## FIELD CHANGE ORDER

RETROFIT ALL VAX 11/780'S AT SYSTEM REVISION LEVEL 2 OR EARLIER TO SYSTEM REVISION LEVEL 3.

FCO VAX R 0003 1 PAGE of 12  
Level of Urgency (LOU)

REWORK PROCEDURE  
FOR  
FCO VAX-R0003

FIGURE 3. LOCATION OF JUMPERS ON THE KA780 BACKPANEL

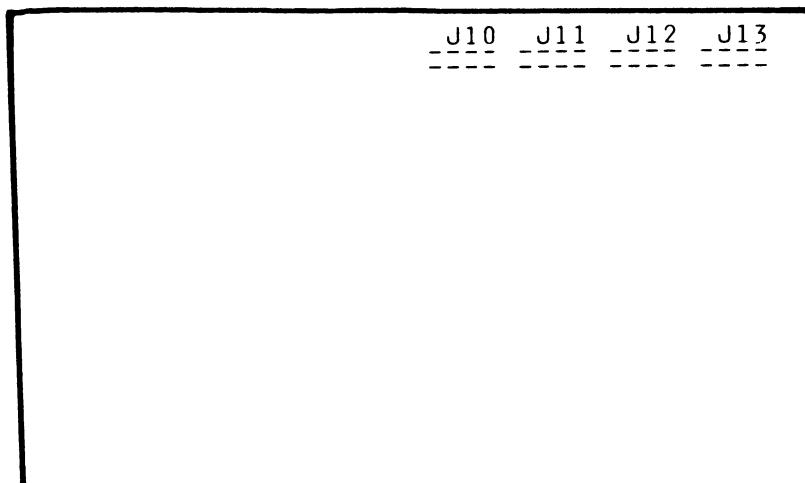
SELECT THE JUMPERS ON J12 AND J13 OF THE KA780 BACKPANEL TO DECODE THE CORRESPONDING BITS AS "0". INSTALL A JUMPER (12-14314) TO GROUND THEM TO THE GROUND PLANE.

PLACE BLUE CONNECTORS (12-14314) ON J12 PIN W AND J13 PIN B OF BACKPANEL TO IDENTIFY SYSTEM REVISION LEVEL 3 IN THE SYSID REGISTER. BITS 19 AND 20 ARE THUS JUMPERED.

FIGURE 4. LOCATION OF BRADY MARKERS

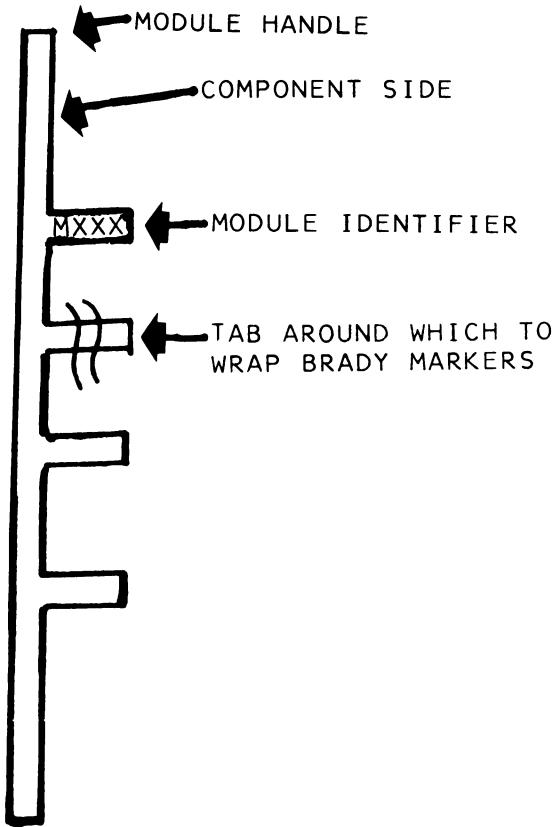
INSTALL BRADY MARKERS AS SHOWN IN FIGURE 4.

D-CS-M8224-0-1  
ETCH REVISION "B"  
CS REVISION "D"  
SHEET 6 OF 13  
ZONE C7

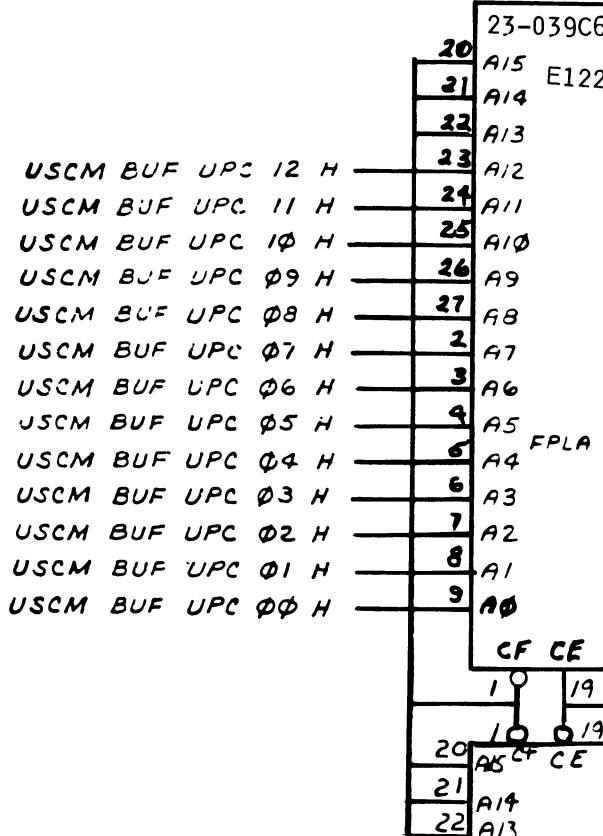
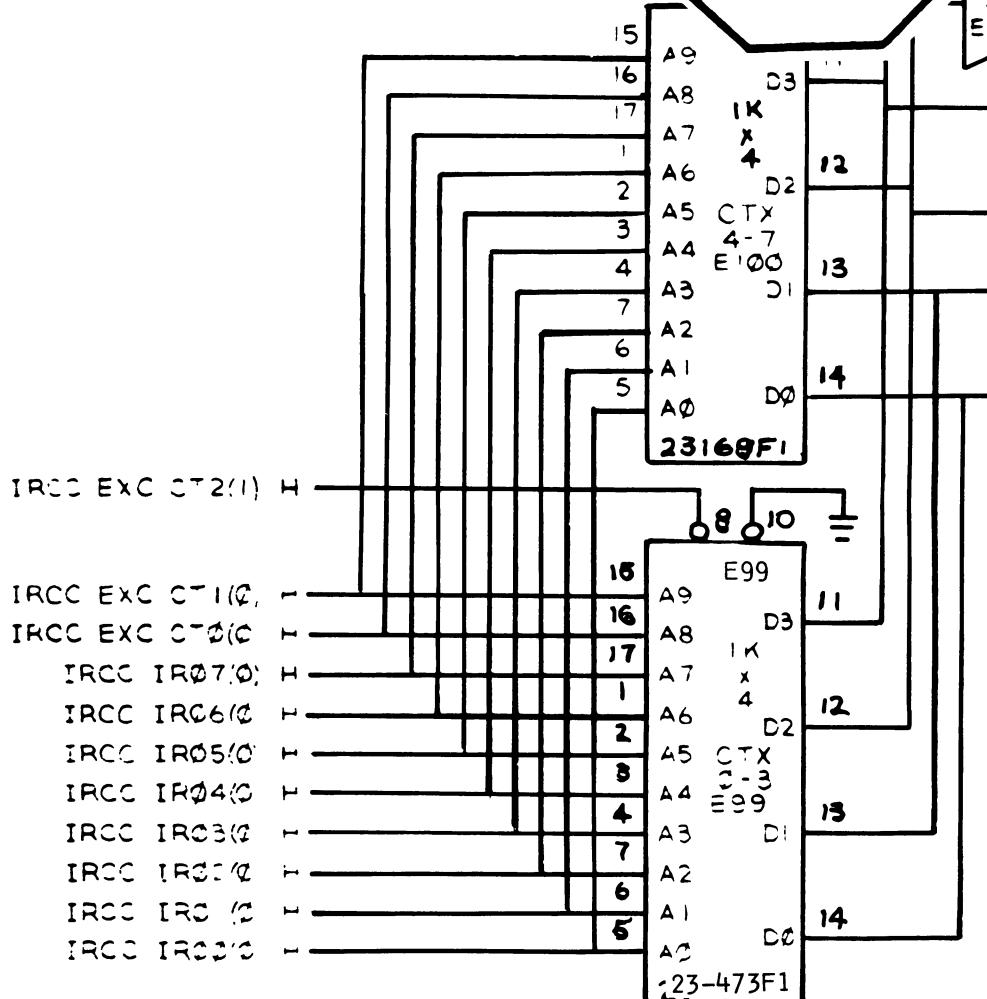
MARK-UP SITE SCHEMATICS SO AS TO INDICATE PROPER REVISION LEVEL. SEE PAGES                    OF THIS FCO.
